RE: **962-972 Franklin Avenue Rezoning (CEQR No. 23DCP165K)**
Assessment of Proposed Council Modifications
ULURP Nos.: C230356ZMK, N230357(A)ZRK, C230358ZSK

DATE: **November 15, 2024**

962-972 Franklin Avenue Rezoning

Figure 1

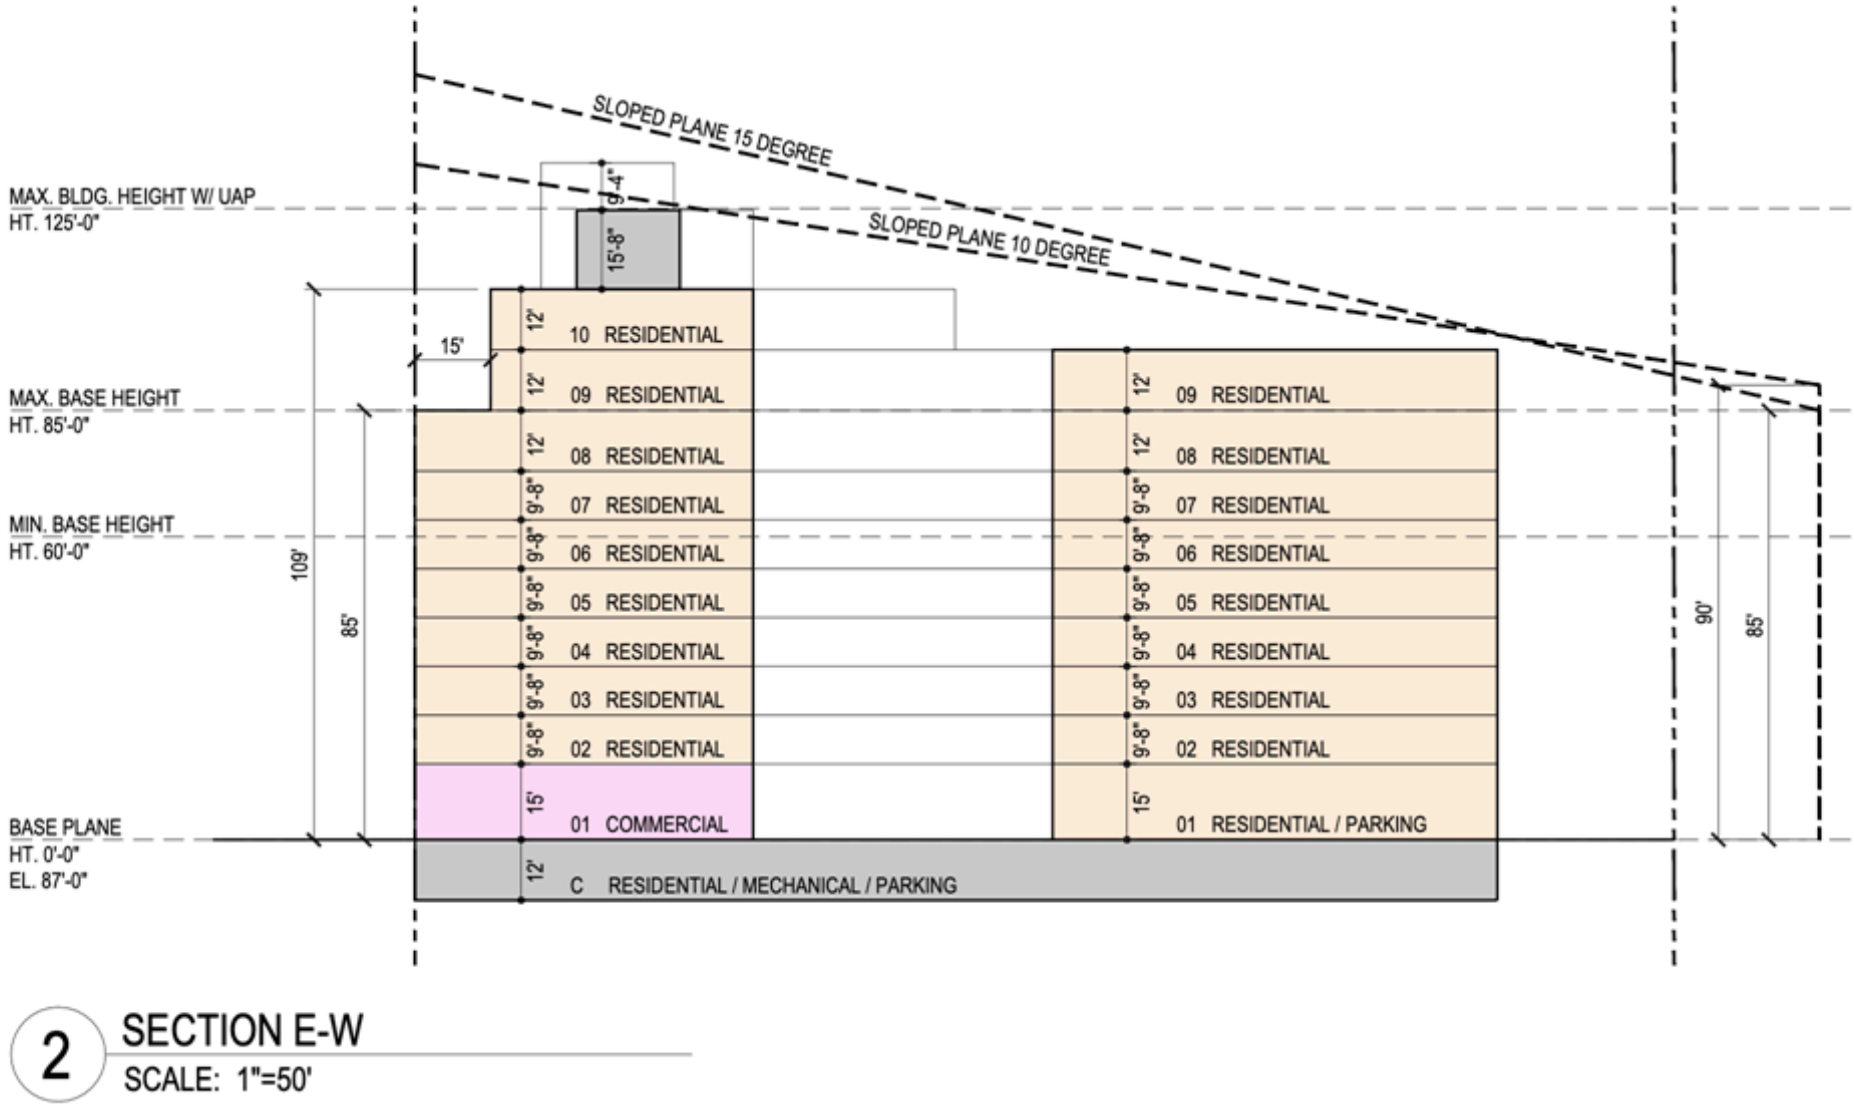
The Proposed Council Modifications, which are being put forward by the Council's Land Use Committee, would retain the inclined height limiting plane of the CPC-approved Project, but would increase the starting elevation to 90 feet, and further reduce the slope so as to rise by 10 degrees towards Franklin Avenue. Within 85 feet of Franklin Avenue, bulkheads would be permitted to penetrate the plane up to 12 feet, which would be below the height of the limiting plane of the CPC-approved Project, provided that no bulkhead was longer than 60 feet and any bulkheads are at least 30 feet apart. A section showing the Proposed Council Modifications height limiting plane, compared to the CPC-approved Project limiting plane, and the resulting proposed massing is shown in **Figure 1**. The intention of this modification is to further restrict the building envelope and thereby further reduce the effects of project-generated shadows on the BBG Resources.
